Radiant Sweater Ind. Ltd. (9945)

Sayem Fashions Ltd. (11476)

19.AUGUST.2014

Identified Priority 1 Concerns

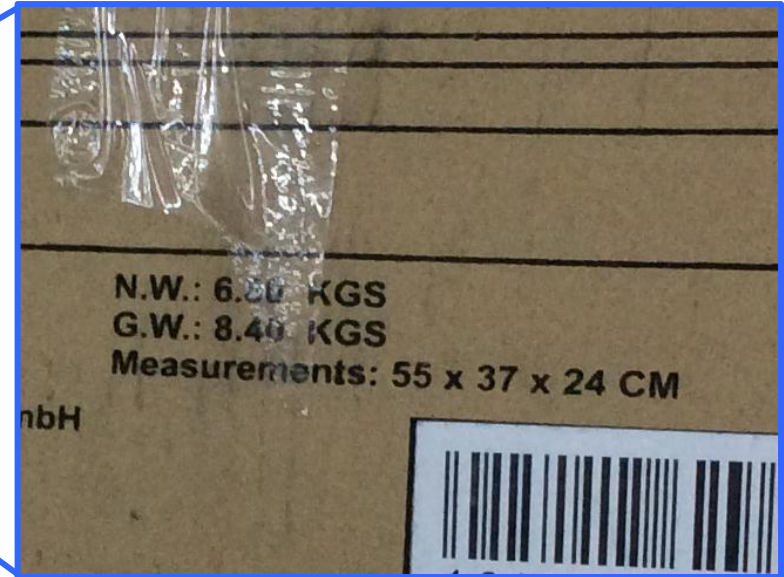
The internal columns at ground level at Building 1 shown below are close to being overstressed. The size of these column is 500 x 500 mm at ground level and carry 8 storeys of Building 1 with 5.75 m and 5.75 m length spans. Uncontrolled heavy storage loading of 4.1 kPa and 6.1 kPa was also found on 2nd floor and 4th floor respectively.

From the information above, for Building 1, 8 storeys, the calculation check of these columns show that they are close to being overstressed (FoS = **1.37**).

Remark: The sizes of the column's rebar are assessed to be similar to those specified on the structural drawings.

In situ	Drawing
Size	500 x 500 mm	550 x 550 mm
Vertical rebar	12-Ø22mm (1.82%)	12-Ø22mm +12-Ø16mm (2.31%)
Aggregate	Brick	Brick

Item No.	Observation	Recommended Action Plan	Recommended Timeline
1	Priority 1 - The internal columns at ground level are close to being overstressed in Building 1.	Maintain and control the floor loading on every floor to ensure the total load does not exceed 2.0 kPa. Factory Engineer to review design, loads and columns stresses in area identified above. Verify in-situ concrete stresses either by cores or existing cylinder strength data for [the identified columns / cores from 4 columns]. A Detailed Engineering Assessment of Factory to be commenced immediately.	Immediate - Now
2	Priority 1 - The internal columns at ground level are close to being overstressed in Building 1.	Produce and actively manage a loading plan for all floor plates within the factory giving consideration to floor capacity and column capacity. The Detailed Engineering Assessment to be completed and any recommended actions carried out.	6-weeks

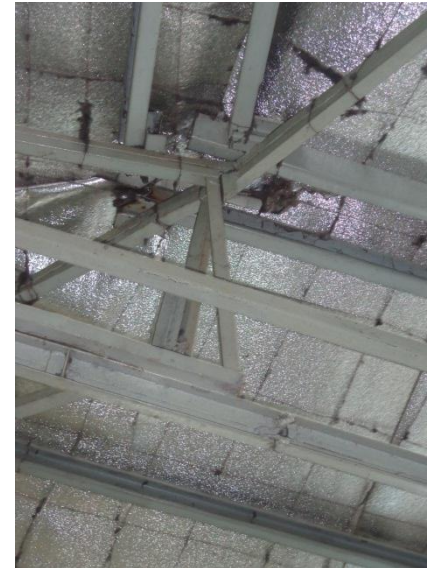
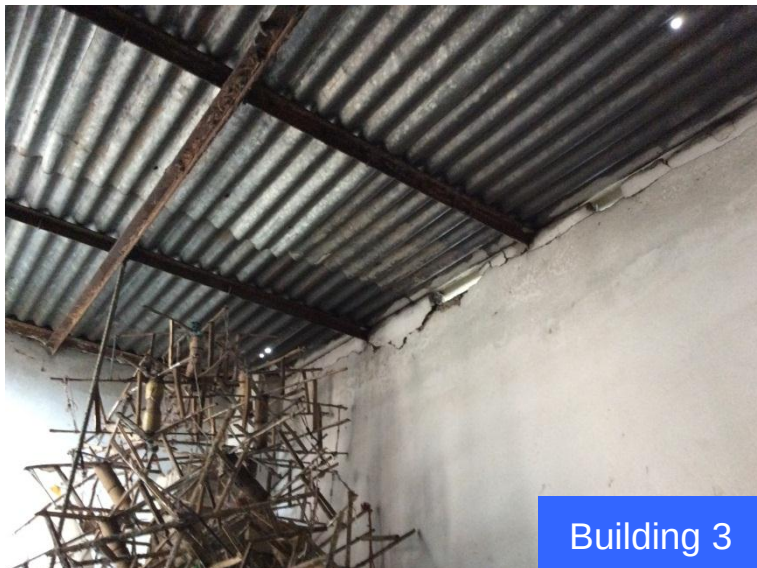
Concerns with the lightweight roof at the top level of these buildings. Stability and capacity must be checked especially with the connections. Stability under wind uplift needs to be checked in particular.

Item No.	Observation	Recommended Action Plan	Recommended Timeline
14	Priority 2 - Stability and capacity of lightweight roofs.	Factory Engineer to review design, loads and related elements in area identified above to confirm capacity and stability for these items.	6-weeks
15	Priority 2 - Stability and capacity of steel staircases in Building 1 and Building 2.	Factory Engineer to review design, loads and related elements in area identified above to confirm capacity and stability for these items. These items should be strengthened or replaced with appropriate permanent structural elements.	6-weeks
16	Priority 2 - Movement joint to be properly established between Building 1 and Building 2.	The Factory Engineer should investigate to prove the capacity of the building in its existing state, a further building approval should be gained for the building as it exists, as altered since the original approval. Alternatively, the extension building should be separated by a non-structural joint and allowed to act as a fully structurally independent structure.	6-weeks

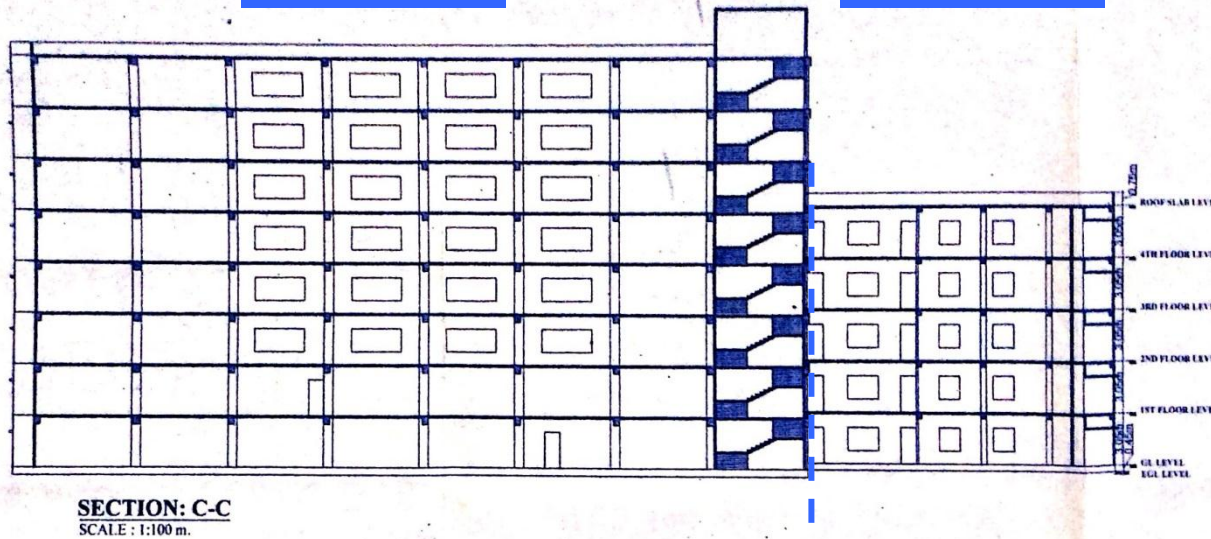
Building 1 and Building 2 were partially connected together. The movement joint should be established properly where shown.

----- Movement Joint

17	Priority 2 - Movement joint to be properly established between Building 1 and Building 2.	Do not construct any further buildings connected to the existing building without thorough structural design and full building approval.	6-months
18	Priority 2 - Overall stability systems.	A Detailed Engineering Assessment of the overall building to be carried out and in particular, stability and foundation aspects should be investigated in detail.	6-weeks
19	Priority 3 - Distress due to water ingress.	Waterproofing on the roof slab is to be applied. Moreover the roof slab drainage system should be investigated and improved.	6-months
20	Priority 3 - No parapet wall or guardrail present at top level on Building 3.	A suitable perimeter parapet wall or guardrail should be constructed along the building perimeter.	6-months
21	Priority 3 - Reinforcement left exposed at top level.	For both durability and serviceability, rust proof paint or any appropriate methods is recommended.	6-months

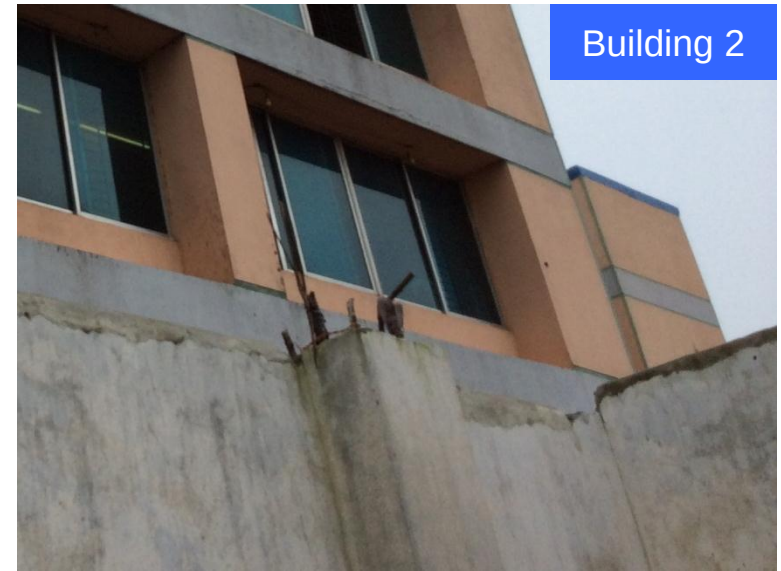
There is no parapet wall around the perimeter of top level of Building 3.

Whilst not a structural issue, this is a significant health and safety risk and should be rectified.

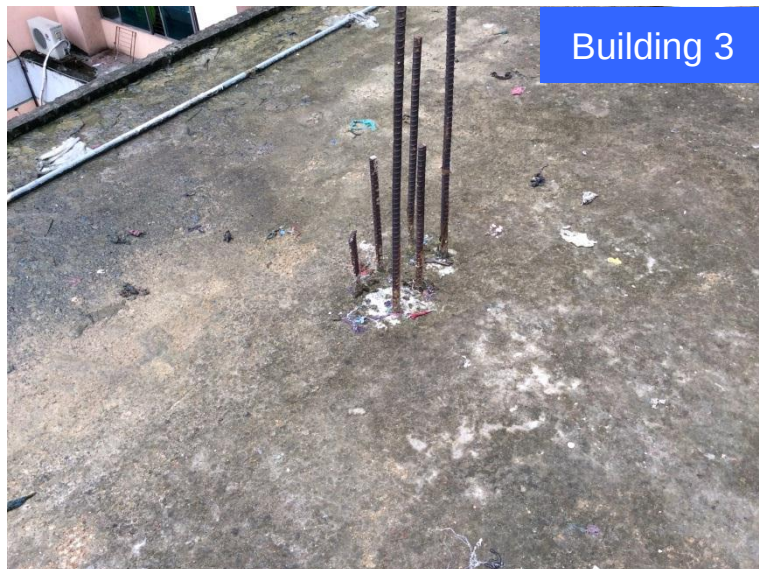
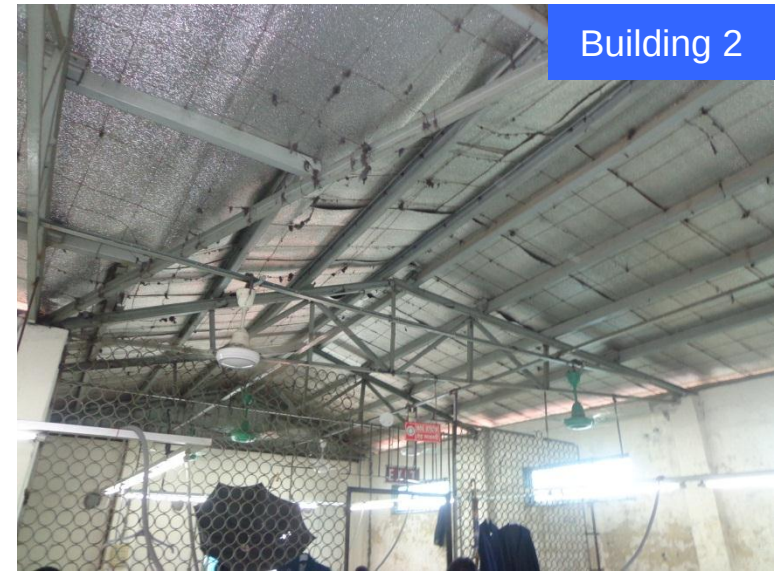
Reinforcement is left exposed at top level of Building 1, Building 2 and Building 3.

Overall Stability System

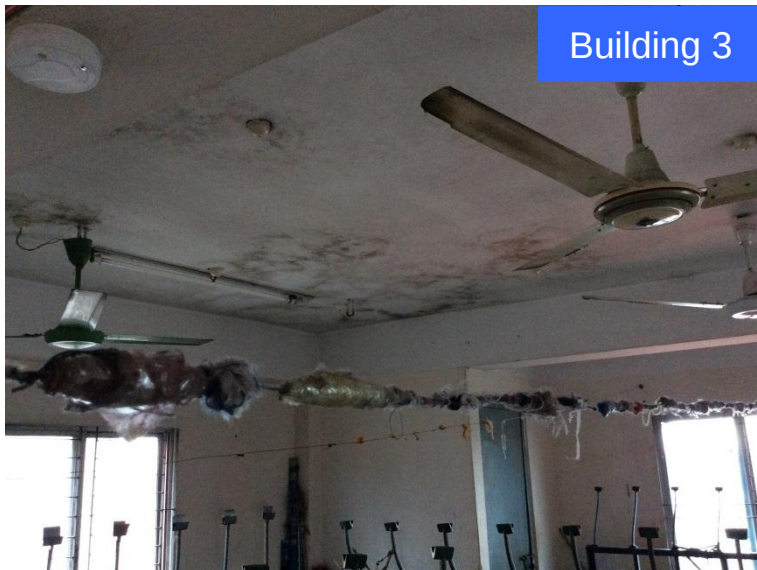
The lateral loading resistance for Building 1, 8-storey building, Building 2 and Building 3; 5-storey buildings are provided by moment frame action without any shear wall and the façade brickwork walls lack moment capacity due to their poor connections with the surrounding columns and beams.

We require that the stability of these buildings is investigated as part of a Detailed Engineering Assessment.
